Access Compliance Report

Public Rights-of-Way

(Curb Ramps)

Intersection ID: N/A	Main Street: W_TYVOLA_RD	Cross Street: N/A	Location: NE
ADA ID: DC95EB78E0CF	Ramp Type: BlendTrans1	Initial Pass/Fail: Fail	Overall Compliance: No
Severity Score: 10			
Codes/Mitigation Info/Possible Solution		Field Measurements/Component Compliance

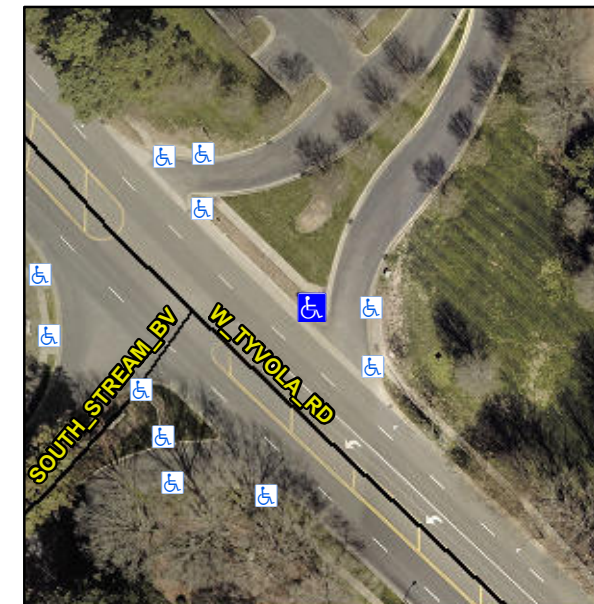
LOCATED ON ISLAND

R304.5.1, R304.5.3

Compliance	Description	Data	Compliance	Description	Data
N/A	Ramp Length (in)	49.0	Yes	BlendTrans Slope (%)	0.1
No	Ramp Width (in)	43.0	No	BlendTrans XSlope (%)	3.6
N/A	Flare Type LT	N/A	N/A	Flare Type RT	N/A
N/A	Flare Slope LT (%)	N/A	N/A	Flare Slope RT (%)	N/A
N/A	Flare Traversable LT?	No	N/A	Flare Traversable RT?	No
N/A	Landing Length (in)	N/A	N/A	DWS Provided?	N/A
N/A	Landing Width (in)	N/A	N/A	DWS Contrast?	N/A
N/A	Landing Slope (%)	N/A	N/A	DWS Length (in)	N/A
N/A	Landing X Slope (%)	N/A	N/A	DWS Full Width?	N/A
N/A	Landing Curb? (Y/N)	N/A	N/A	DWS Offset (in)	N/A
N/A	Shared Landing?	N/A			
N/A	Gutter Ponding?	N/A	N/A	Gutter Slope (%)	N/A
N/A	Gutter Lip Ht (in)	N/A	N/A	Gutter X Slope (%)	N/A
N/A	Painted X Walk1?	No	N/A	Painted X Walk2?	N/A
	X Walk 1 Direction	To SE		X Walk 2 Direction	N/A
	X Walk 1 Width (in)	N/A		X Walk 2 Width (in)	N/A
	X Walk 1 Slope (%)	1.1		X Walk 2 Slope (%)	N/A
	X Walk 1 X Slope (%)	3.2		X Walk 2 X Slope (%)	N/A

Remove & Replace Curb Ramp With Two New Directional Ramps or Equivalent.
